ADDENDUM# 6

UK Level B Support Services BP-2
ADDENDUM No. 6
CCK-2655-23
10/11/2022

BP-2_ADDENDUM NO. 6

Subject: Renovate/Upgrade UK Healthcare Facilities
Pavilion A Level B Support Services Renovation
UK # 2239.77

LEVEL B DEMOLITION PLAN AREA A PHASE 6
D10B-A.6 SCALE: 1/8" = 1'-0"

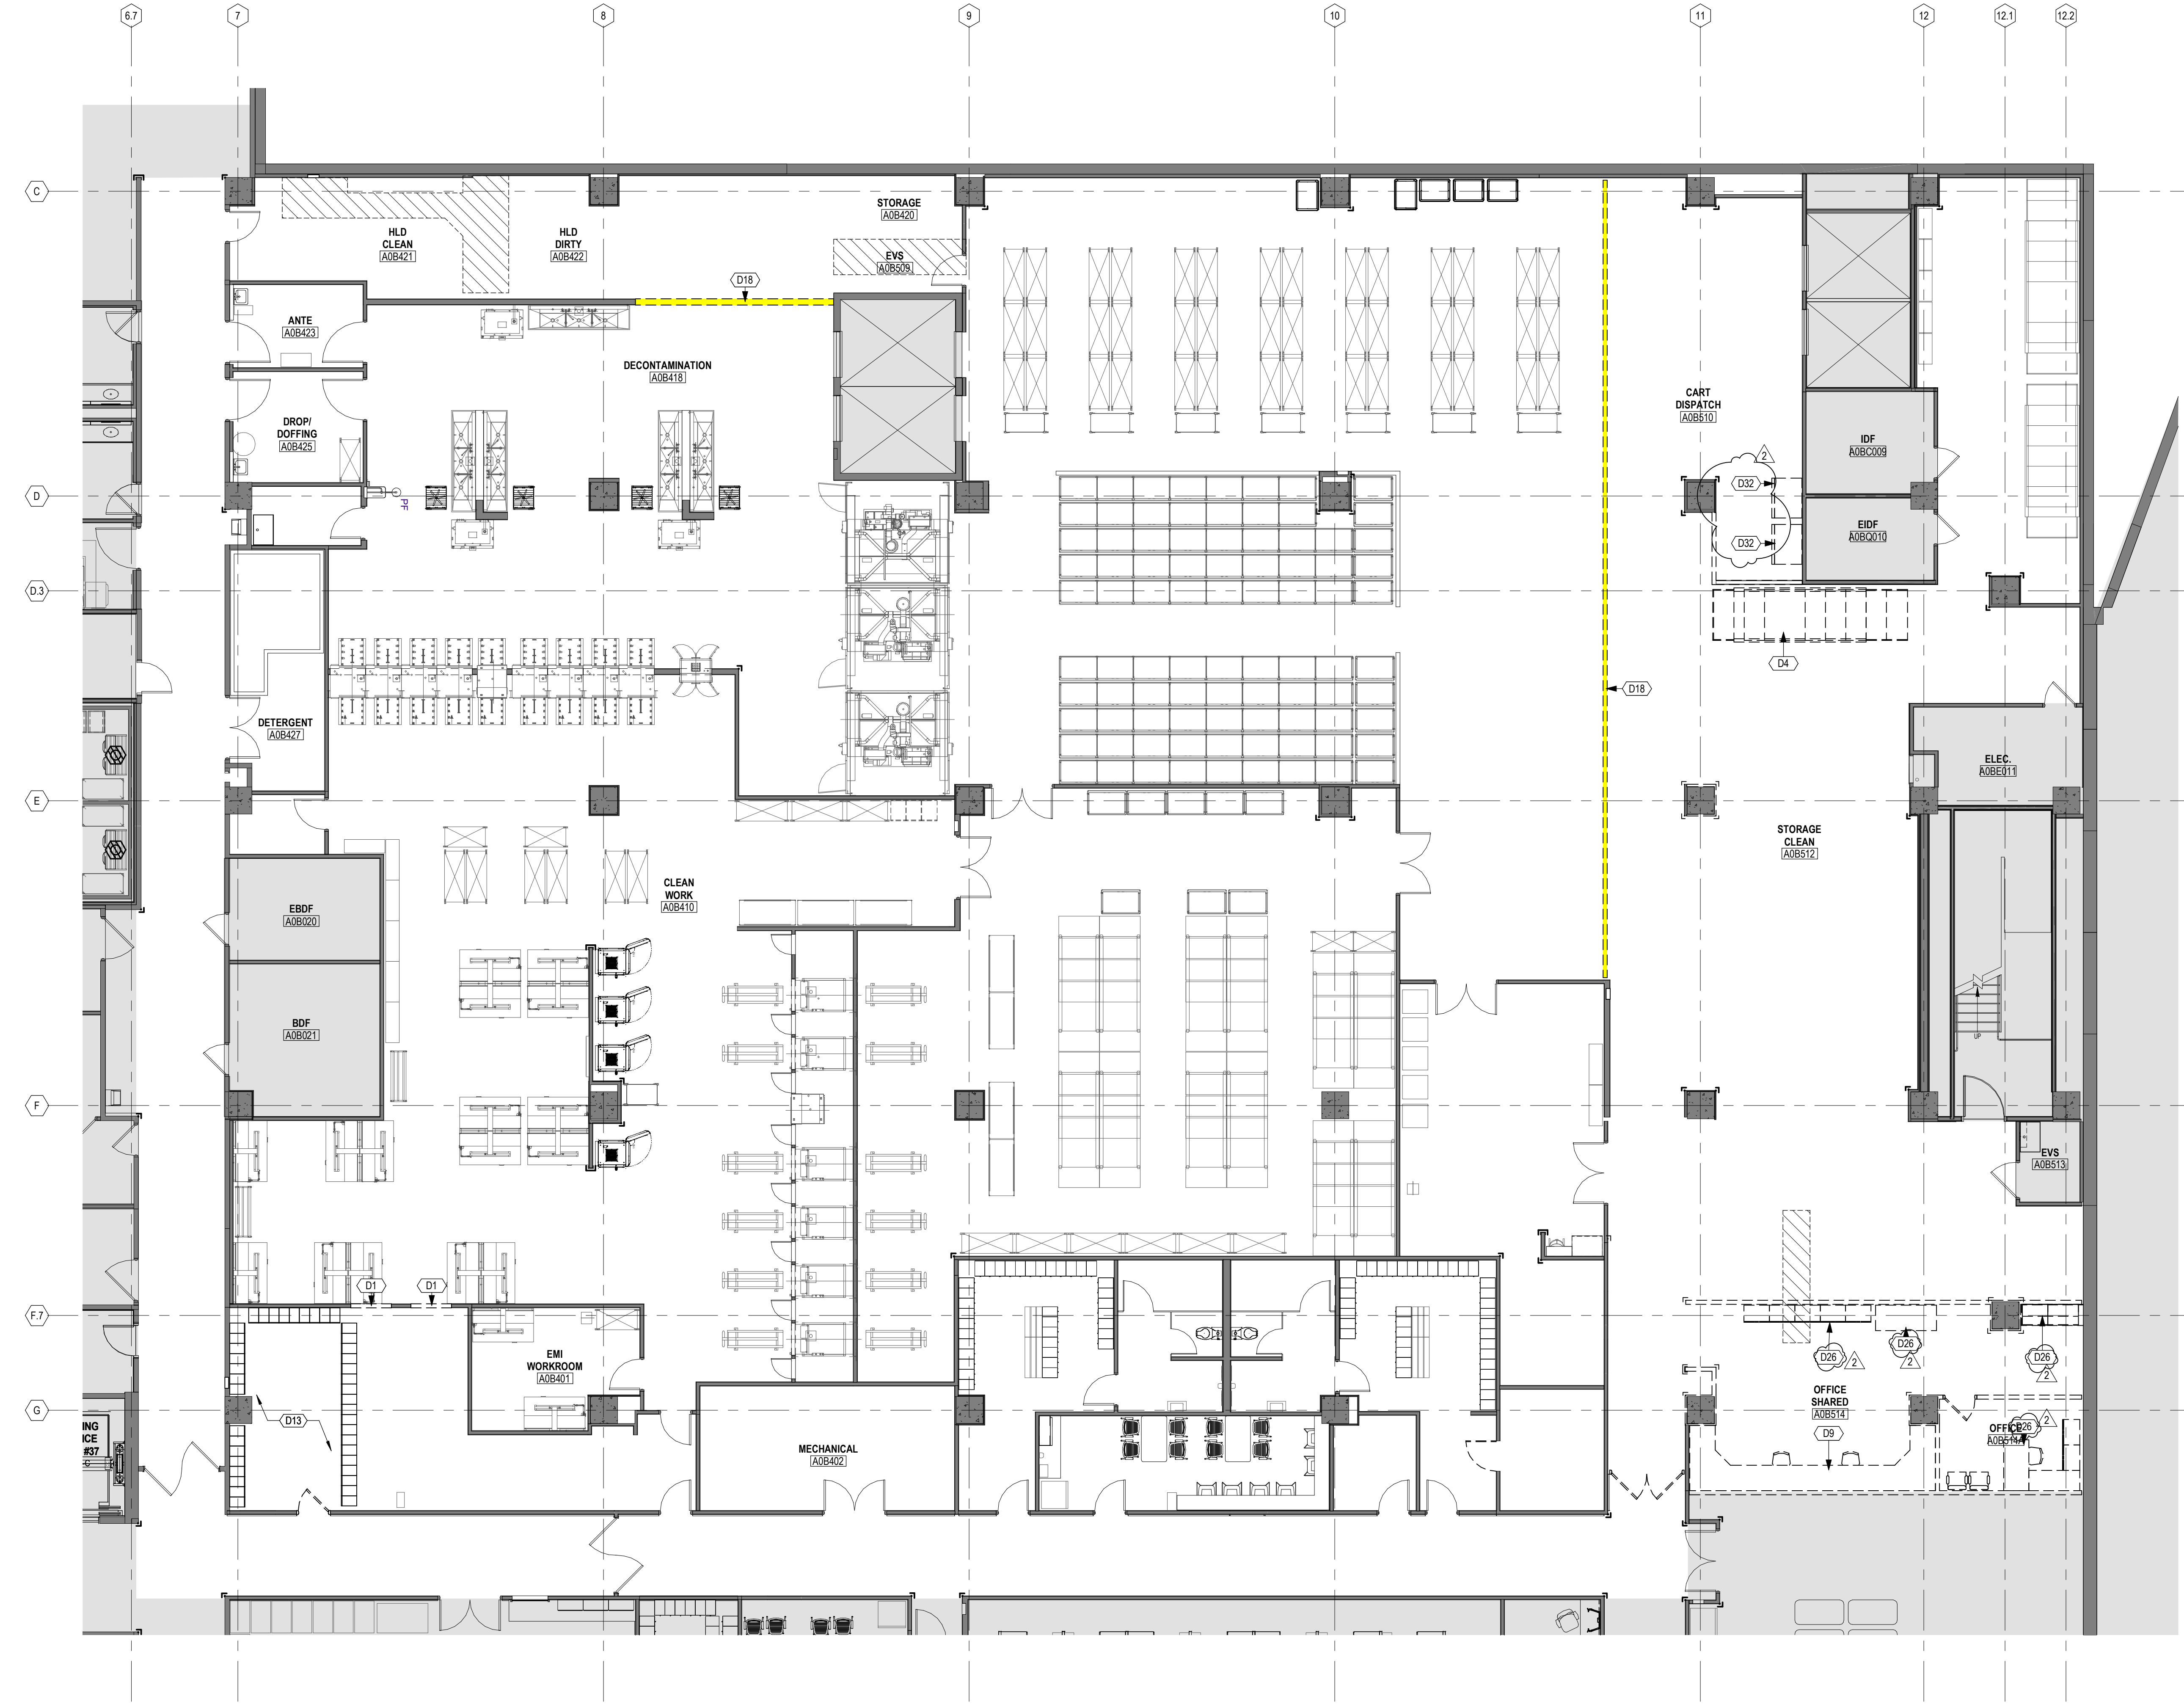
- A. See clouded areas
- 2.8 Sheet A10B-A.1 LEVEL B DEMOLITION PLAN – AREA A PHASE 2**
 - A. See clouded areas
- 2.9 Sheet A10B-A.2 LEVEL B DIMENSION PLAN – AREA A PHASE 2**

11.	Demo note D4 "Remove high density shelving and salvage for reuse": Is the intent that all shelving and railing be removed? Is shelving and railing to be relocated & stored on-site, off-site, or turned over to the owner?	Note is updated in Addendum 6

KEYNOTE	DESCRIPTION
D1	REMOVE EXISTING WALL FOR NEW OPENING
D4	UNBOLT EXISTING HIGH DENSITY SHELVING. SALVAGE TO PAV A SHIPPING DOCK
D9	REMOVE EXISTING CASEWORK
D13	REMOVE EXISTING LOCKERS AND BENCHES - CONTRACTOR TO REMOVE AND TRANSPORT TO PAV A 2ND FLOOR
D18	TEMPORARY WALL SHOWN FOR REFERENCE. CM TO CONTROL TEMPORARY BARRIER LOCATIONS. WORK BY GENERAL TRADES.
D26	EXISTING DOWNPIPE TO BE DEMOLISHED BY CONTRACTOR
D32	CONTRACTOR TO DISCONNECT FREEZERS AND TRANSPORT THEM TO PAV A LOADING DOCK. SEE E0508A NUMBER FR20889 FOR FUTURE RELOCATION LOCATION.

LEVEL B DIMENSION PLAN - AREA A PHASE 2

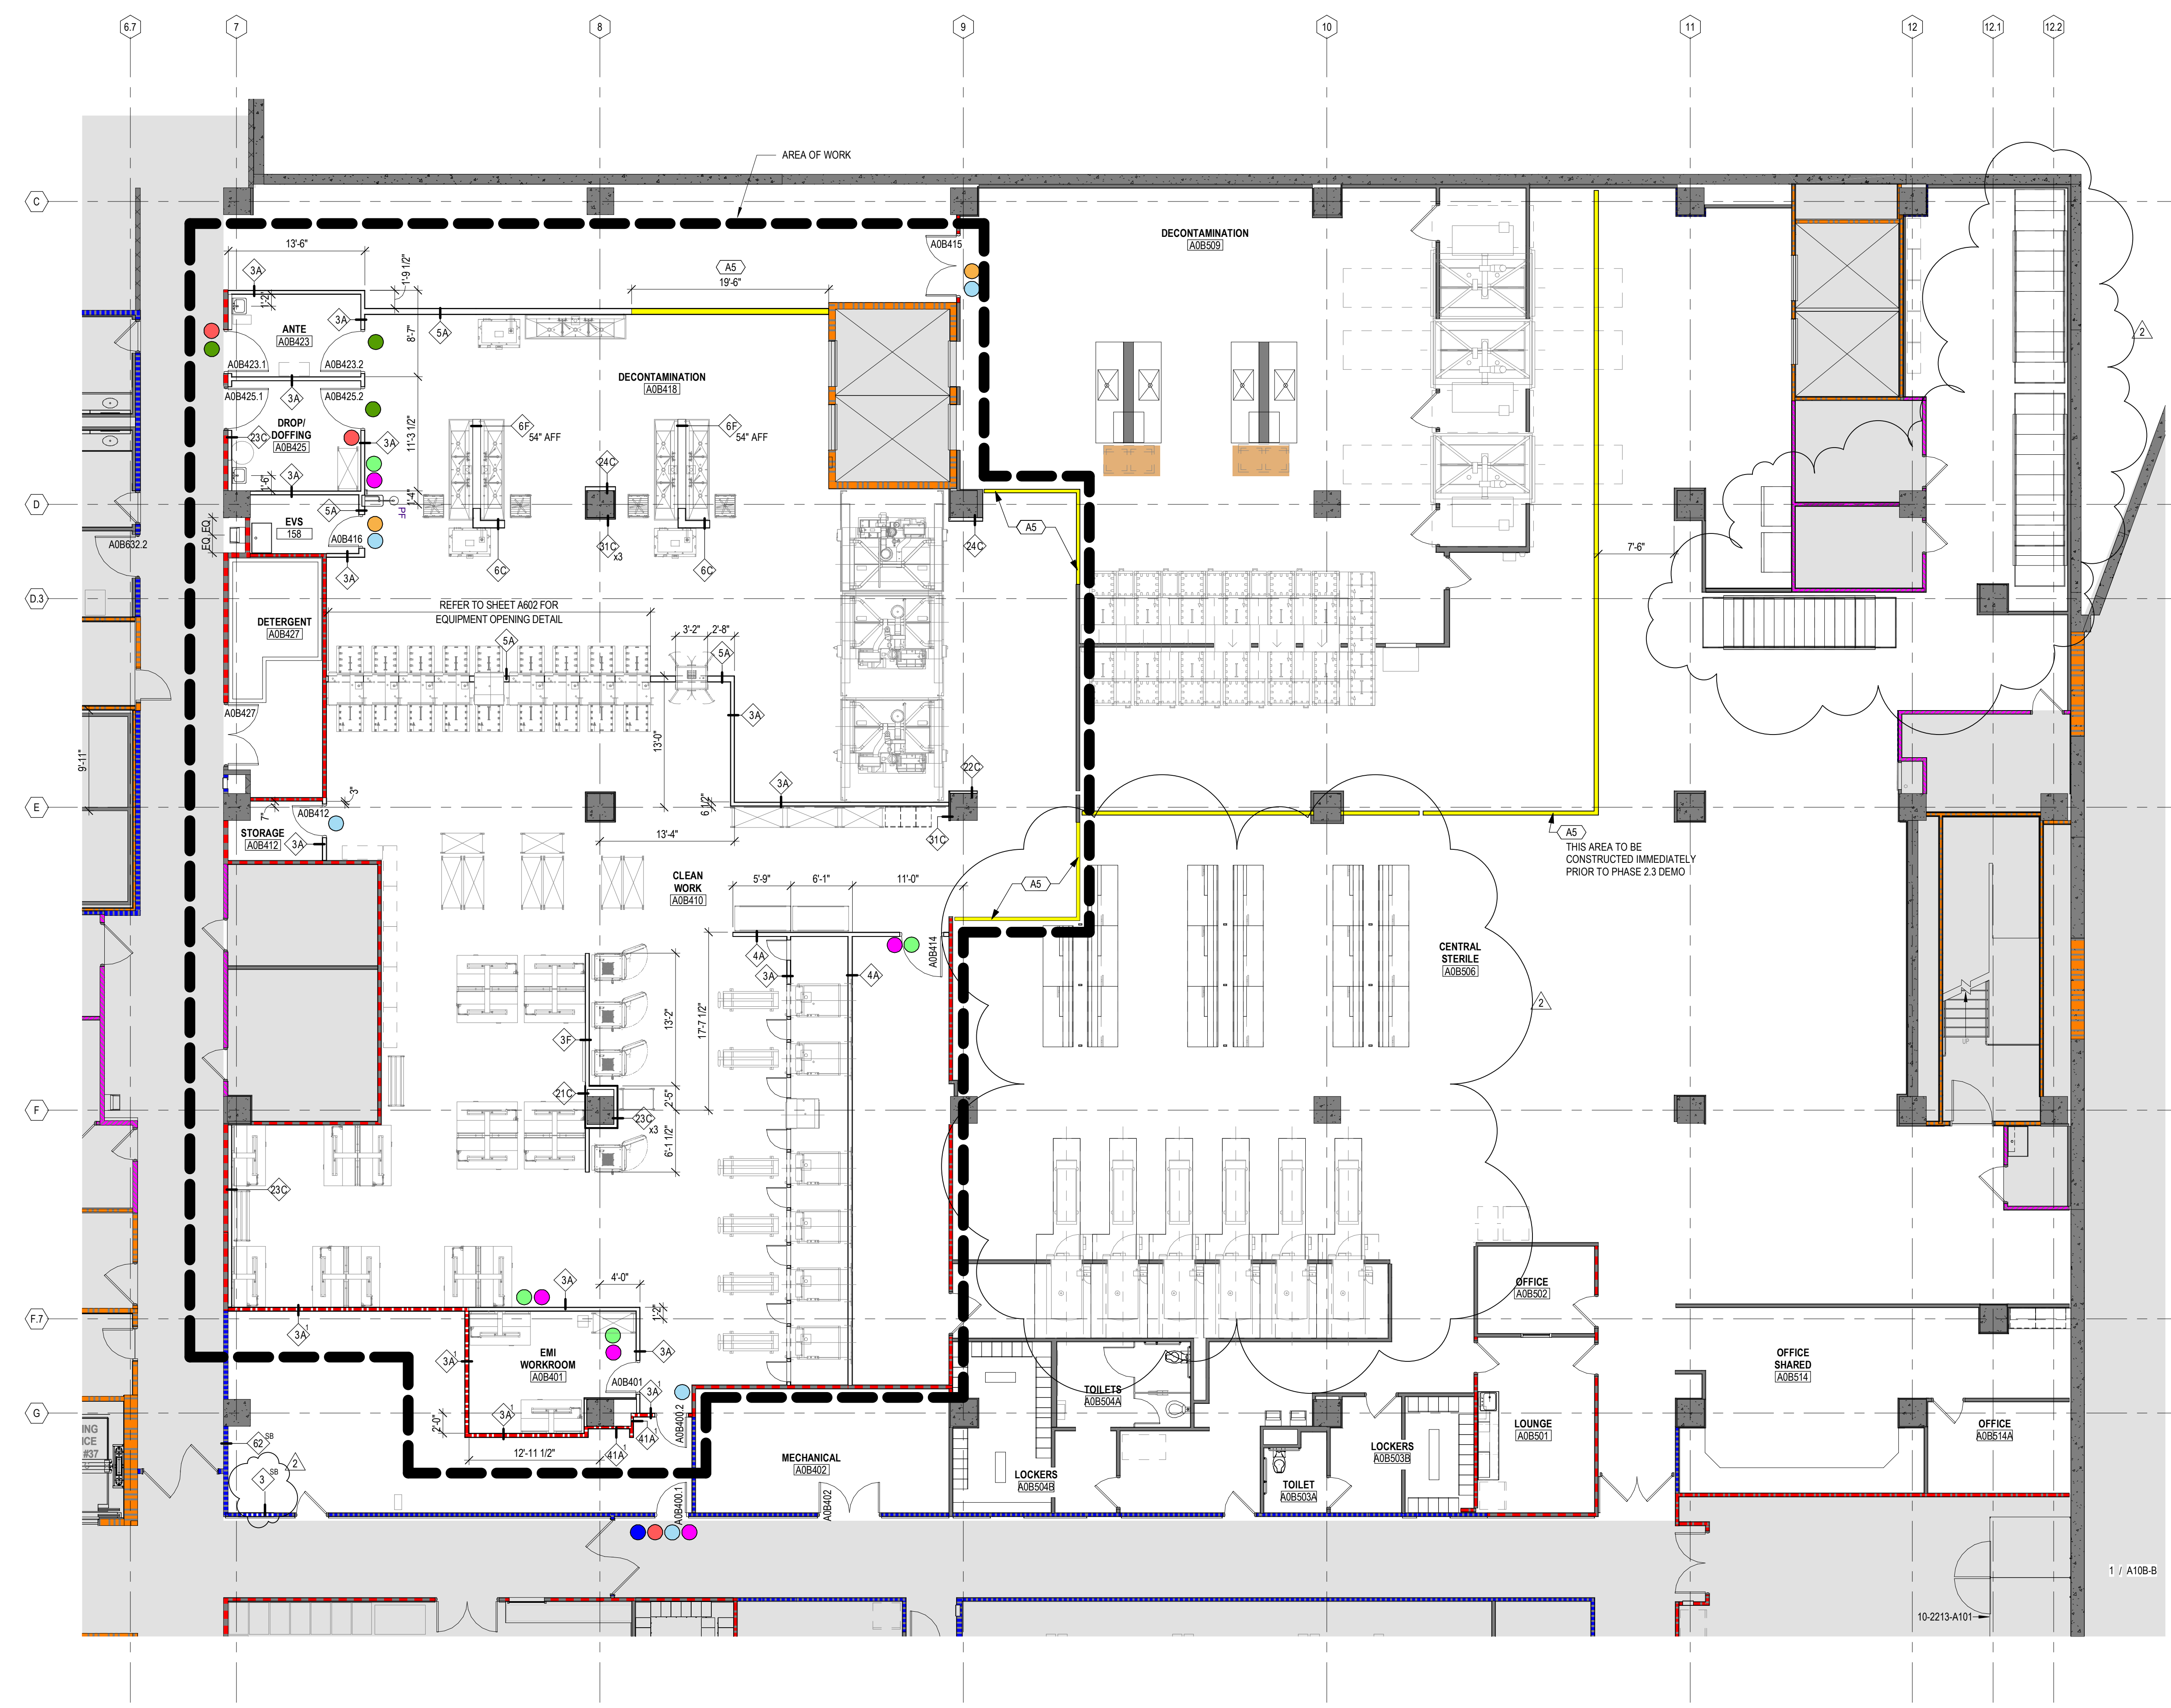
- A. See clouded areas and reference numbers in door schedule
- 2.10 Sheet A10B-A.3 LEVEL B DIMENSION PLAN – AREA A PHASE 2**
 - A. See clouded areas and reference numbers in door schedule
